LOCATION: Frankford Road, east of Highland Springs Way**DATE FILED:** January 5, 2023**ZONING:** MC-3, RR**CITY COUNCIL DISTRICT:** 12 **SIZE OF REQUEST:** 18.74-acres **MAPSCO:** 6G**APPLICANT/OWNER:** Hare Krishna Krupa, LLC, Rita D. Santamaria, Pack Properties XII, LLC

REQUEST: An application to replat an 18.74-acre tract of land containing part of Lot 1 in City Block D/8759 to create 3 lots ranging in size from 1.732-acre to 14.1070-acre on property located on Frankford Road, east of Highland Springs Way.

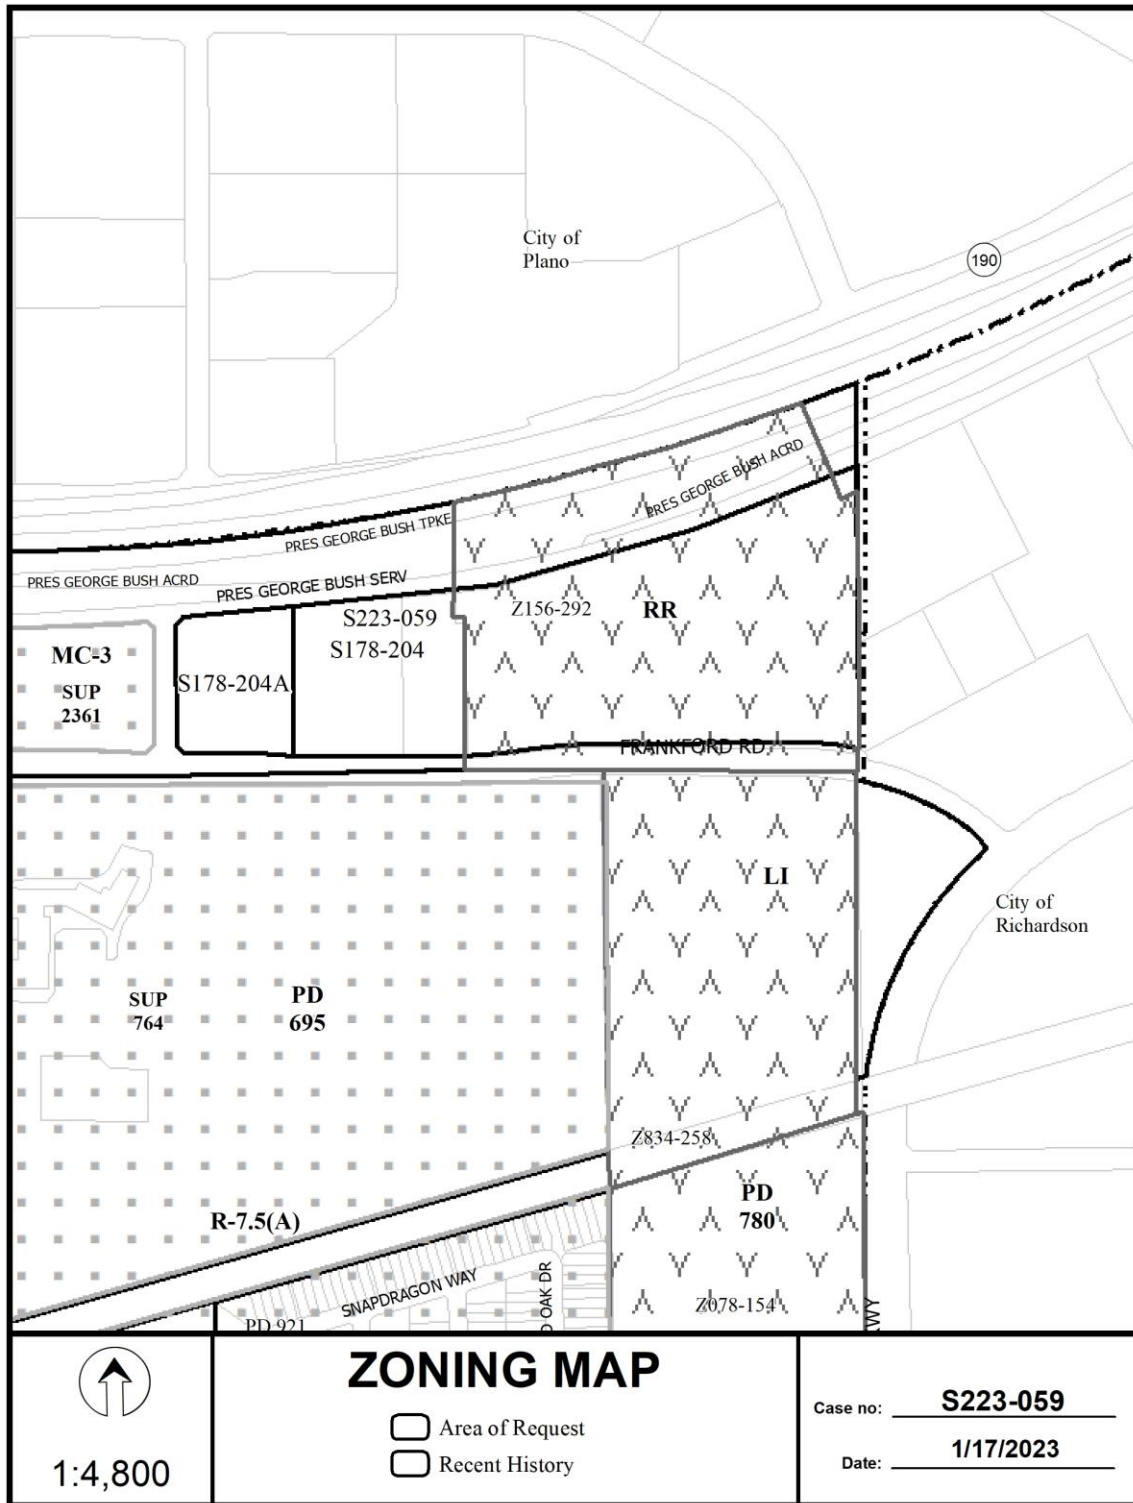
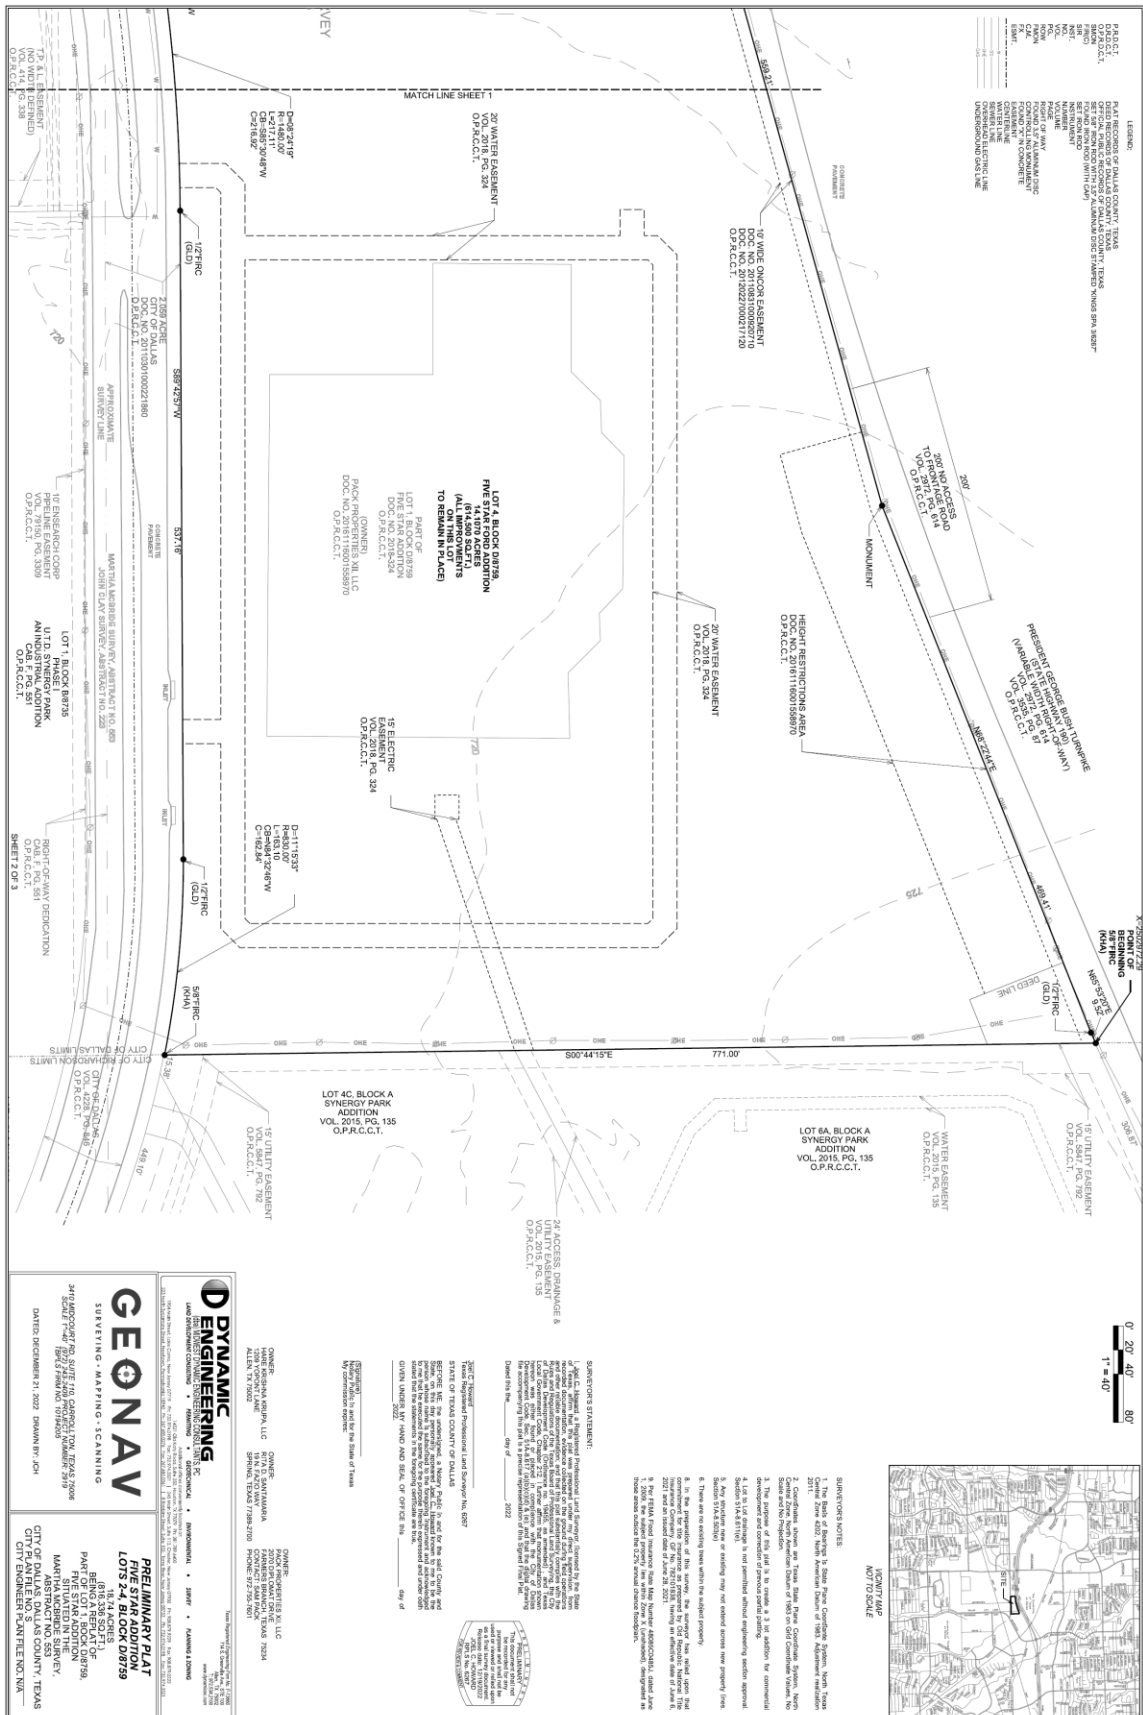
16. Prior to final plat, submit a completed final plat checklist and all supporting documents.
17. On the final plat, show the correct recording information for the subject property. Platting Guidelines.
18. On the final plat, show recording information on all existing easements within 150 feet of the property.
19. On the final plat, chose a new or different addition name. Platting Guidelines.

20. Additional design information is required for assessment. Site plan must be submitted showing proposed development, building finished floor elevation, development, existing mains – including downstream manhole, and proposed water and wastewater service locations. Submit water/wastewater engineering plans to 320 E. Jefferson Blvd., Room 200, Attention: Water and Wastewater Engineering.

21. On the final plat, add a label for “Frankford Road” on all sheets. SEC. 51A-8.403. (a) (1) (A) (xii)
22. On the final plat, identify the property as Lots 1B-1D in City Block D/8759. Ordinance 1A, Page 131 pages 131-148, Section 2 (passed August 13, 1872).
